**Economic Commission for Europe****Inland Transport Committee****World Forum for Harmonization of Vehicle Regulations****Working Party on Passive Safety****Seventy-second session**

Geneva, 5–9 December 2022

**UN Regulation No. 17 (Strength of seats)****Proposal for the 11 Series of Amendments to UN Regulation  
No. 17 (Strength of seats)****Submitted by the expert from Germany\***

Model C

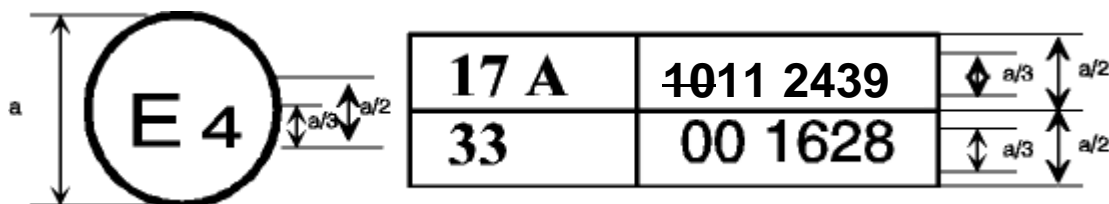
The approval numbers indicate that, on the dates when approval was granted, UN Regulation No. 17 included the ~~4011~~ series of amendments but UN Regulation No. 33 was still in its original form. The above approval mark also shows that the vehicle type was approved pursuant to UN Regulation No. 17 with regard to the strength of any seats on the vehicle which are not fitted or capable of being fitted with head restraints.

Model D

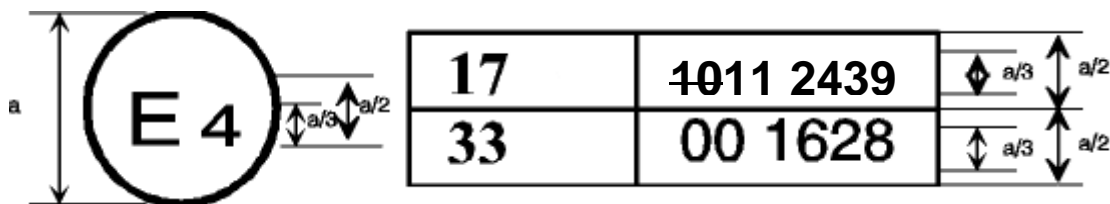
The above approval mark when affixed to a vehicle shows that the vehicle type has seats not fitted or capable of being fitted with head restraints, and was approved in the Netherlands (E 4) pursuant to UN Regulations Nos. 17 and 33.<sup>1</sup> The approval numbers indicate that, on the dates when approval was granted, UN Regulation No. 17 included the ~~4011~~ series of amendments but UN Regulation No. 33 was still in its original form.
